14 WEST ROY STREET

PROPOSED NEW MIXED-USE CONSTRUCTION PROJECT:

14 West Roy Street, Seattle, WA

BOARD GUIDANCE: SUMMARY OF RESPONSE

Height, Bulk, Scale & Massing Guidance

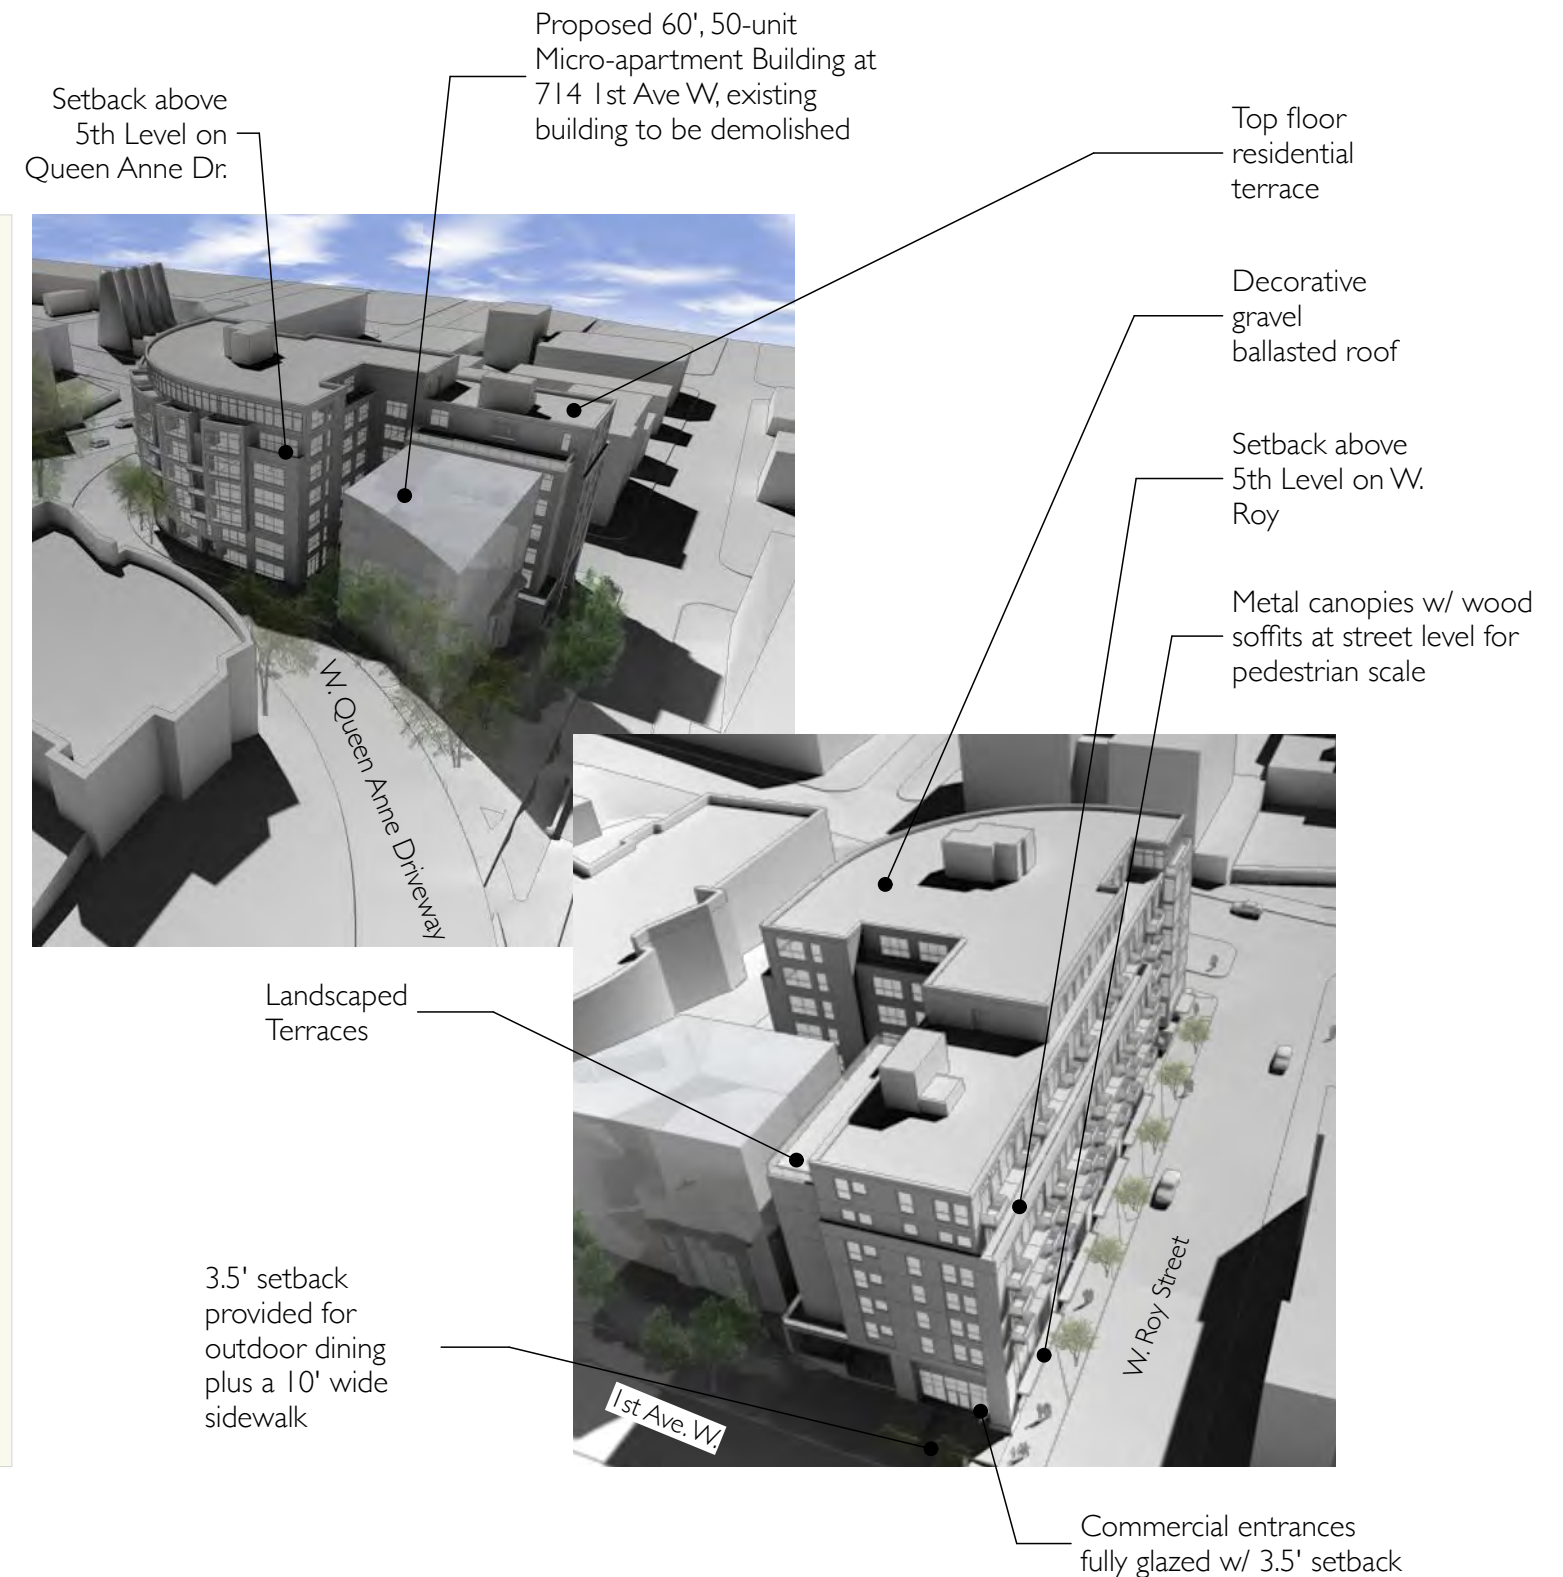
- Provide upper level setbacks above 4th or 5th stories to break down scale and bulk. (CS2-D, CS2-B)
- Move the mass of the building to the south to create an urban edge. (CS2-D)
- Provide additional setbacks and residential-scaled modulation. (CS2D)
- Refine massing on north/address shadows on northern neighbor. (CS1-B, CS2-D)
- SE corner scale critical, stepping the mass to provide a transition (show perspectives viewed from the west and east) (CS2-A1, CS2-C1, CS2-D, CS2-III, DC2-A2, DC2-III-iii)

- 2 Story setback is provided above 5th Level at northwest corner on W. Queen Anne Driveway and W. Roy.
- 3 stories are setback above 5th level at W. Roy with a 5' terrace at the 6th floor. and additional setback at the 8th floor.
- Mass brought forward to south
- Setbacks at upper floors at southeast corner with increased modulation along W. Q.A. Driveway and W. Roy
- Shadow study of northern neighbor provided; no shadow impact on Bayview terrace March to October (Solar Study on p. 10)
- Further delineation of the SE corner with setbacks at the top one floor

QUEEN ANNE DRIVEWAY

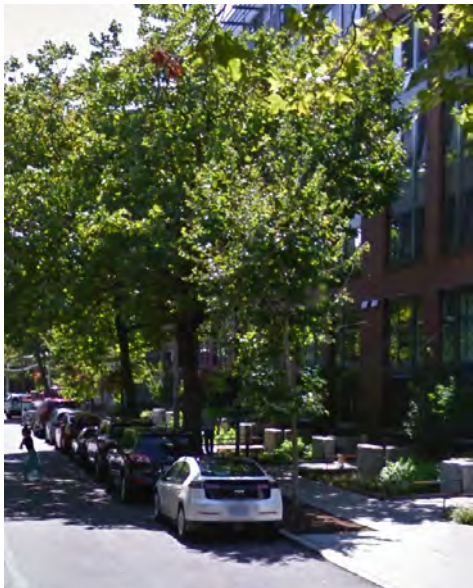
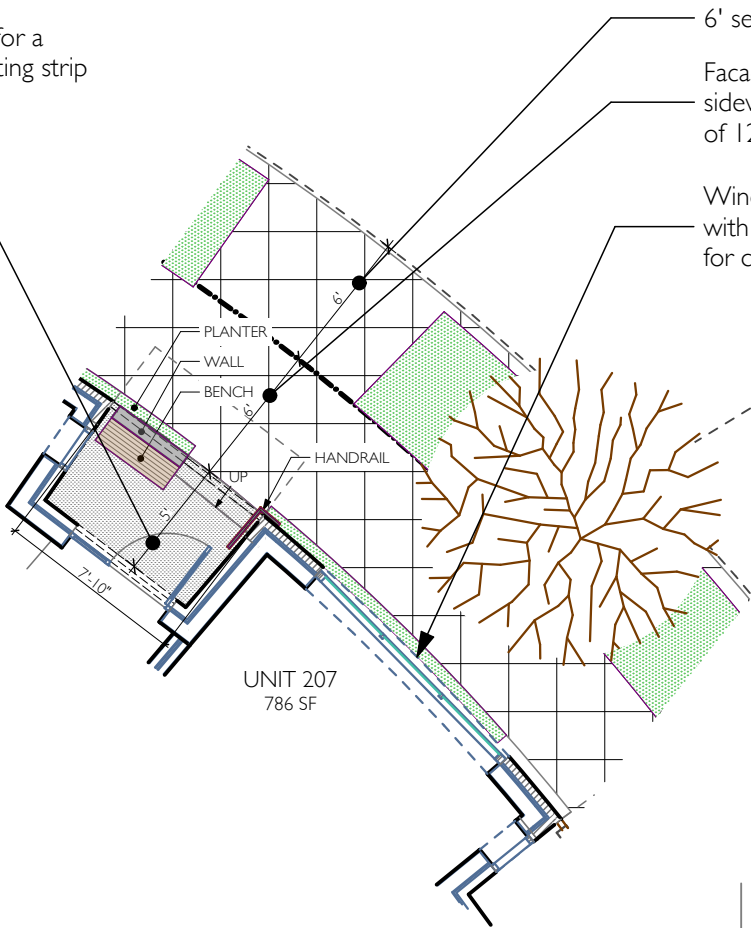
- Provide additional setbacks on W. Queen Anne Driveway to create a sense of spaciousness, transition and buffer for each live/work entry; focus on defining individual units with architectural detailing and a sense of rhythm. (CS2-B1, CS2-D, PL3-A3)
- The Board conditionally supported the reduced setback on W. Queen Anne Driveway as long as an additional setback was provided for adequate space for front entries. The 10' proposed is not adequate, (CS2-D, PL1-B)

- The live/work entries are regularly spaced 25' apart, with the entry alcoves approximately 8' wide and 5' deep. The entrance alcoves are provided weather protection, varied color panels, individual addresses and a low screen wall element at the building facade to enhance privacy. Each live/work unit is fronted by a street tree and landscaped planting strip.
- The facade along W. Queen Anne Driveway is setback an additional 2' for a total setback of 6', providing for a SDOT compliant 12' wide pedestrian zone with curb, tree planting strip and 6' sidewalk. Live/work entrances are setback in alcoves, an additional 5', providing a total 17' setback from the curb at each entry door.

W. ROY STREET RETAIL FACADE

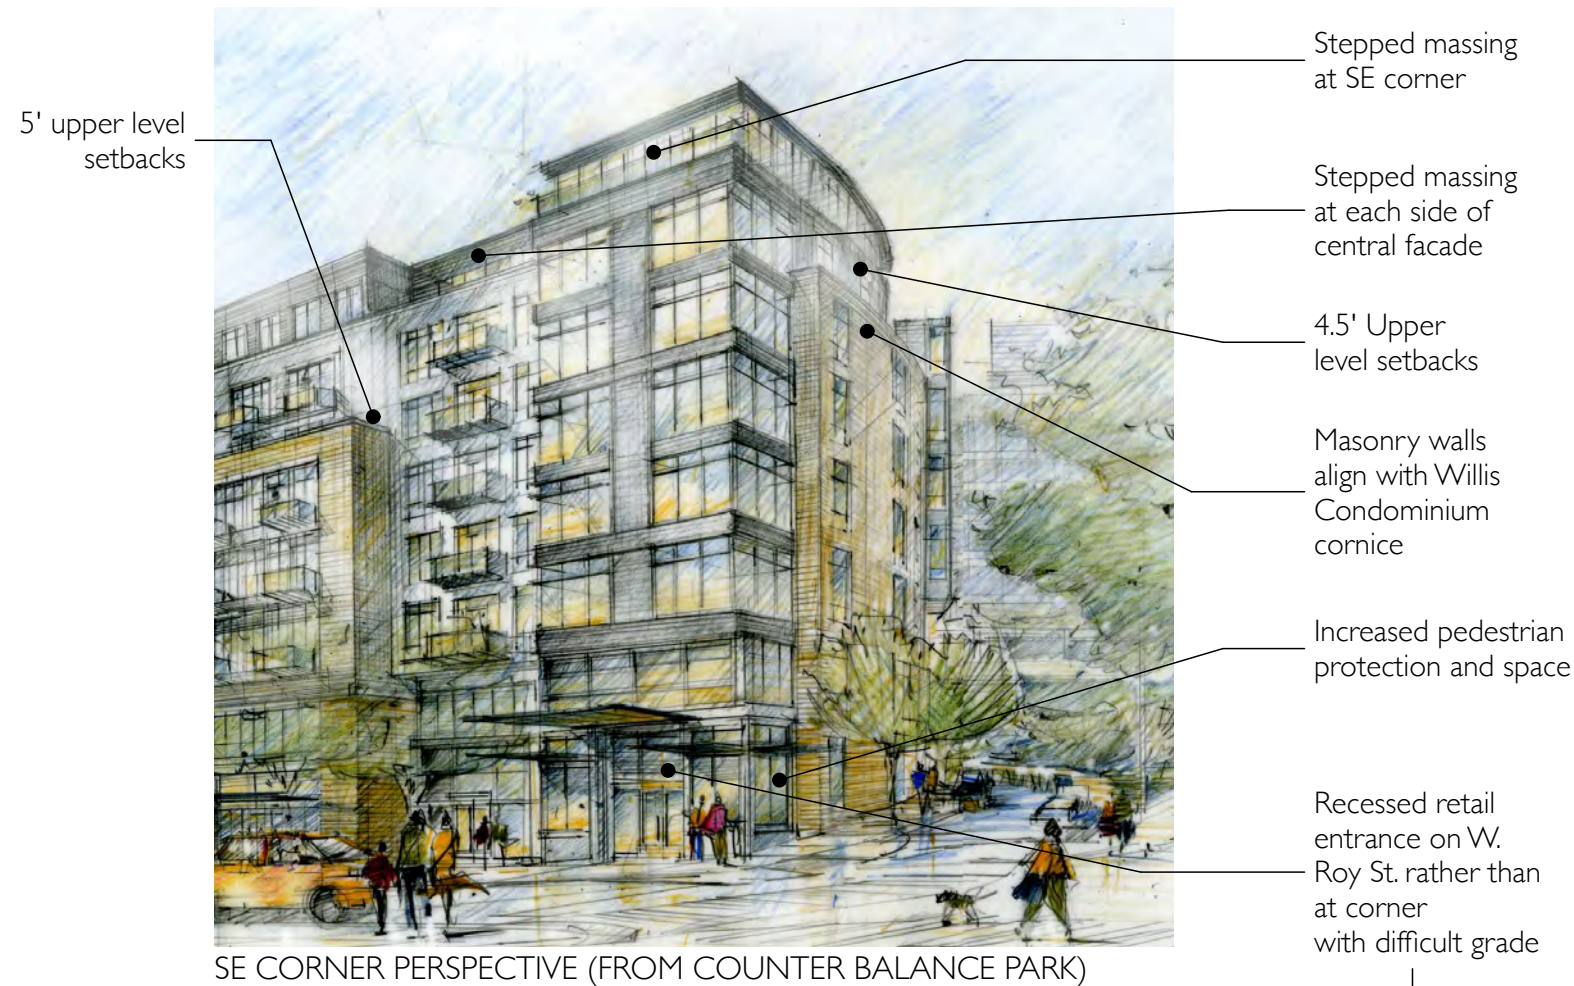
- The Board supported the location of retail and upper level office, stressing that interface with public realm and retail expression does not get lost in scale of the building. (CS2-D, CS2-II-iv, PLI-B, PLI-C)
- The Board supported retail use at both corners and strongly encouraged linking to nearby uses, such as the On the Boards Theater by providing ample site furniture at southwest corner. (CS2-I-i, CS2-II-iv, PLI-B, PLI-A2, PLI-C1)

- Clear distinction has been provided for commercial and residential W. Roy frontage
- SW corner streetscape designed to provide outdoor dining terrace. Retail entrance at southeast corner fully glazed and provides recessed entrances and corner setbacks (see pg. 13)

SOUTHEAST CORNER

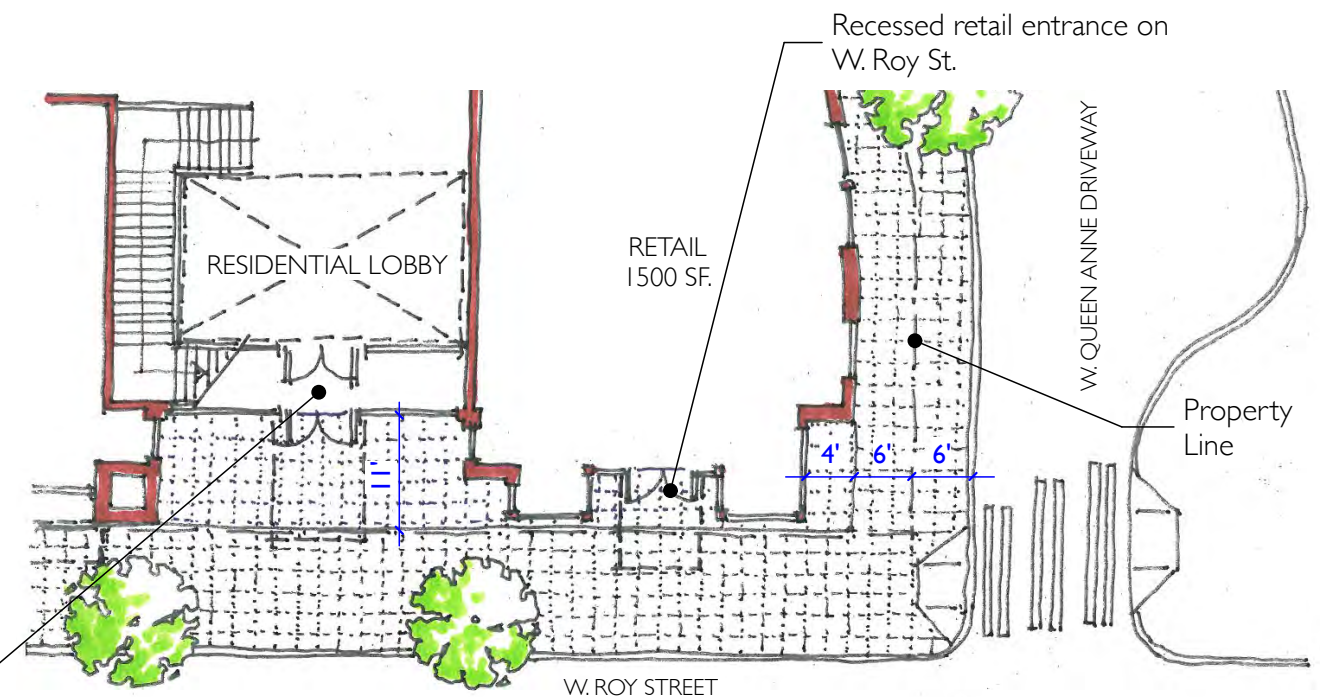
- Scale relationship at corner is critical; vary the massing to provide a transition to the Uptown district. (CS2-A I, CS2-C I, CS2-D, CS2-III, DC2)
- If corner entrance is included, provide iconic gateway with adequate gathering space and over head weather protection. (CS2-II-iv, CS2-III, CS3-A, PL I-B, PL2, DC2-III-iii)
- Consider a corner design that reflects the "Queen Anne style" beyond simple fenestration changes. (CS2-A I, CS2-C I, CS2-III, CS3-A)

- Massing stepped at each side of central facade
- Masonry walls align with Willis Condominium cornice
- Corner entrance not compatible with grade or right of way
- Overall massing of Roy Street facade reflects traditional Uptown rectilinear architecture

The massing has been refined to define the building form and the multiple uses on the south east corner. The lower commercial/retail levels are defined by storefront glazing and the entrance defined multiple canopies wrapping the corner, combining to create a clear, pedestrian presence. The residential mid-level stories are designed with over-scale façade elements, visually combining floors in a strong, unified design element. The upper story is setback to create a termination to the corner element that ties back to the east and north upper story setback elements.

ROOFSCAPE

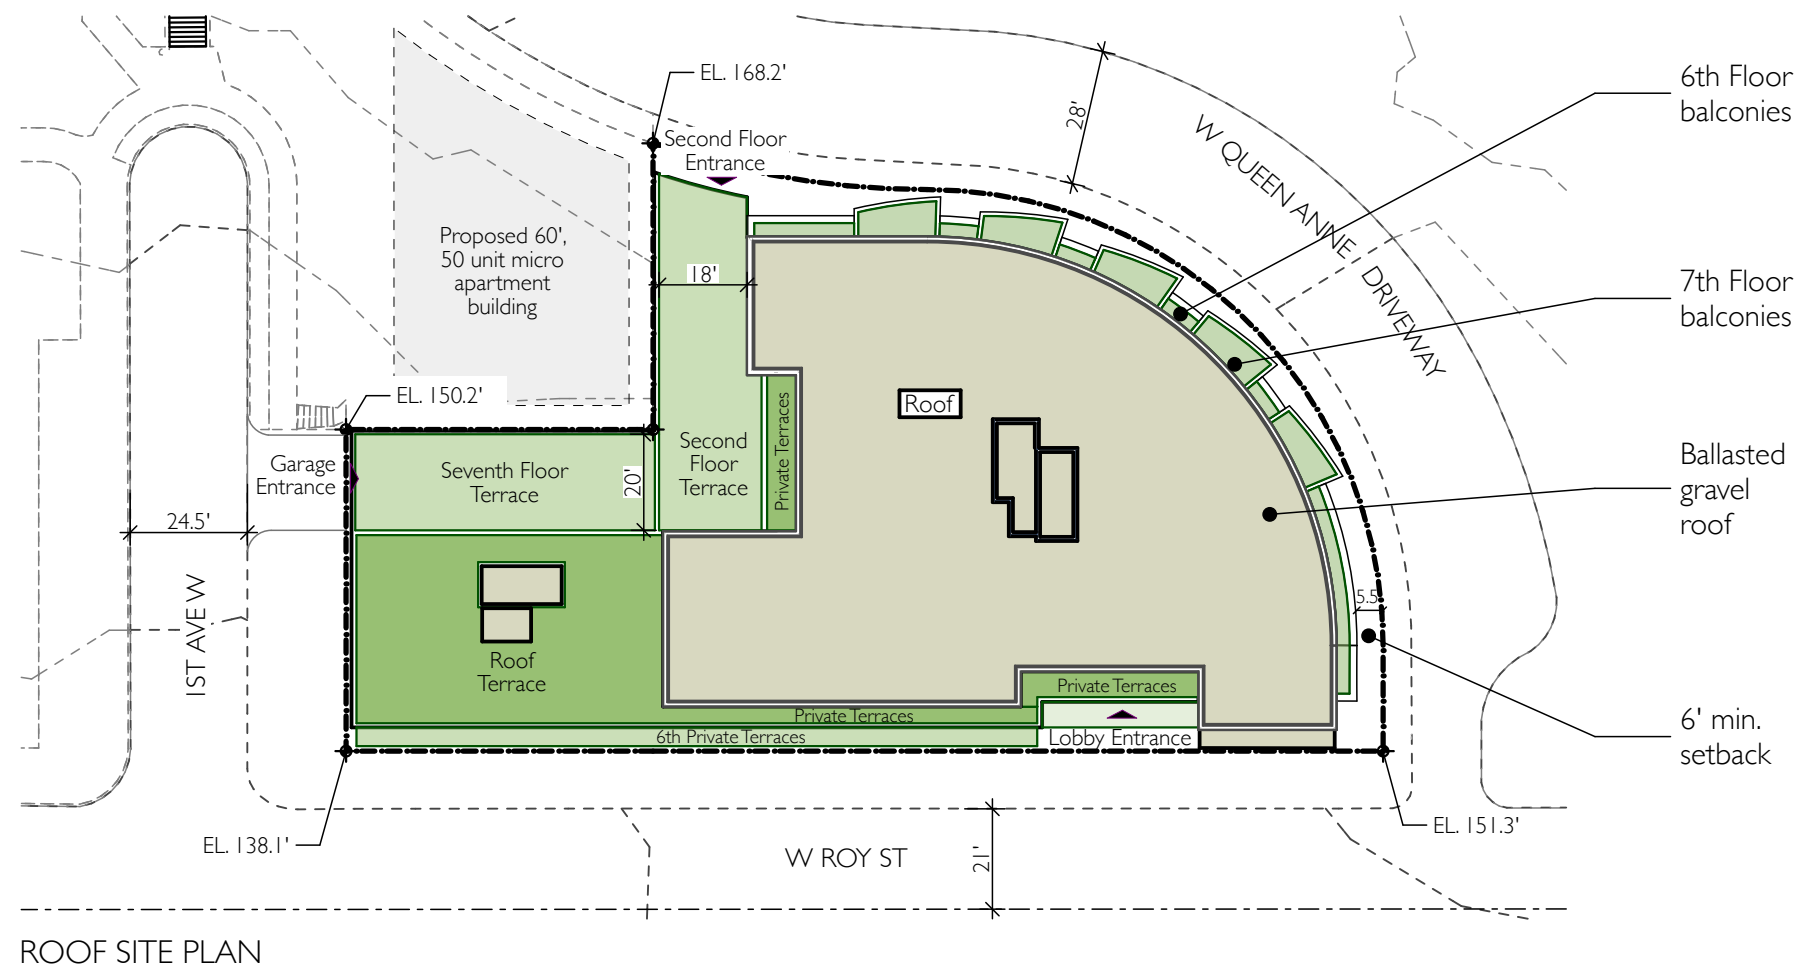
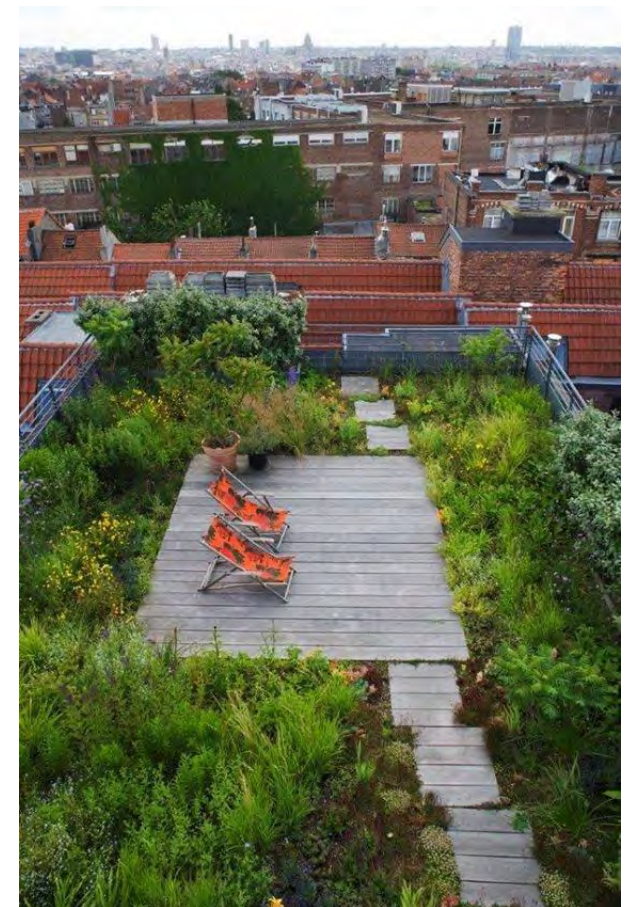
- The design should consider the views of the roof from buildings further up Queen Anne Hill.

- The revised design includes roof terraces at three levels.
- There are landscaped, accessible terraces at the 2nd, 4th and 7th Floors. These terraces provide both outdoor access for building tenants and visual amenity for adjacent structures.
- For the roof of the 8th Floor, which is not accessible by tenants, we are proposing a patterned, colorful gravel ballasted roof surface. This approach will reduce the heat island effect, minimize any glare and provide a visual relief compared to a common roof surface for the neighboring buildings.
